SERVICE DIRECTIVE BULLETIN NO. 0090

Revision 2

1. SUBJECT:    12 Vdc Voltage Control System Modification

Revision 2 updates an installation procedure (Para. 5.2.3.3, Notes 3 and 4 (Page 5)) and hardware part numbers (Para. 6.1) and corrects a typo (Para. 5.2.3.6).

**FIGURE 2. VOLTAGE CONTROL INSTALLATION**

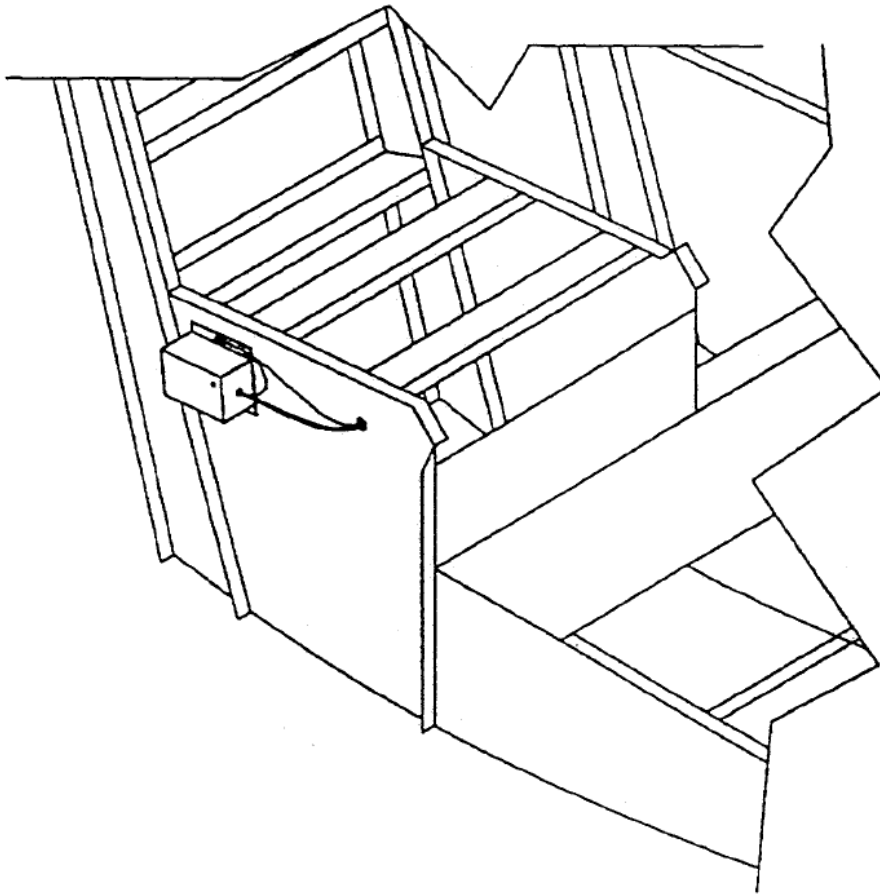
- 5.2.3.4. Refer to Figure 2 and install the electrical wiring for the voltage control, alternate switch, and the “ALT EXC.” circuit breaker.
- 5.2.3.5. If required, reinstall the battery.

- NOTES:
1. If the "ALT EXC." circuit breaker is already installed in the aircraft, disregard note 2 and do not modify the wiring from the bus side of the "ALT SW" to the aircraft bus.
  2. Connect wire 28-4 to the aircraft bus at one of the installed circuit breaker bus terminals.
  3. Connect the "BLACK" lead of the voltage control and wire 27-3 to the case ground/seat structure.
  4. Use 16 Gauge wire as required.
  5. F1 at alternator and the black lead of voltage control must be at the same ground potential.
  6. Connect the ground wire 27-2 to case ground. Do not connect it to the AUX+ terminal
  7. All wiring to be accomplished in accordance with AC 43B-1A.

**FIGURE 1. VOLTAGE CONTROL INSTALLATION IN SEAT STRUCTURE**

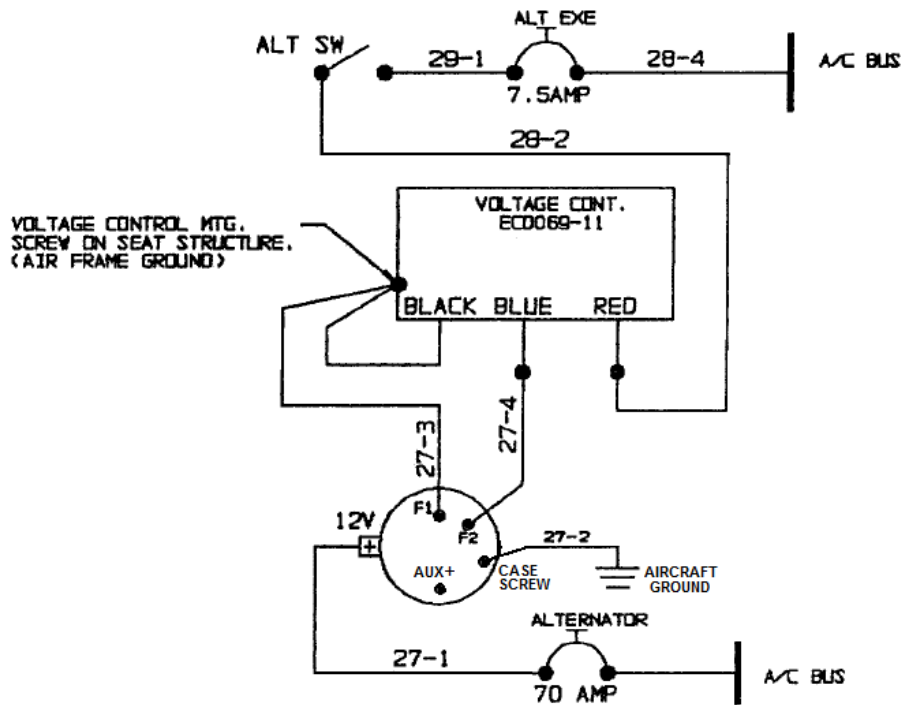
- 5.2.3.3. Install the voltage control on the outside of the seat structure as far aft as possible and with the edge of the mounting flange 1 inch/2.5 cm from the top of the seat structure (refer to Figure 1). If the voltage control interferes with the battery installation in this position, the voltage control may be installed on the inboard side of the seat structure. Remove any paint and clean the area around the top mounting hole in the seat structure to provide a case/terminal ground. Apply CP8-TB Kopr-Shield on mounting flange of the voltage control and on the bare metal mounting surface.

- NOTES:
1. Install the voltage control on the outside of the seat structure as far aft as possible with the edge of the mounting flange 1 inch/2.5 cm from the top of the seat structure. Install the voltage control on the inside of the seat structure if it interferes with the battery installation.
  2. Install an AN931-4-7 Grommet in the seat structure as required for wiring installation.
  3. Remove any paint and clean the area around the top mounting hole in the seat structure to provide a case/terminal ground. Apply CP8-TB Kopr-Shield on mounting flange of the voltage control and on the bare metal mounting surface.
  4. Use hardware listed in Paragraph 6.1 to install the voltage control.
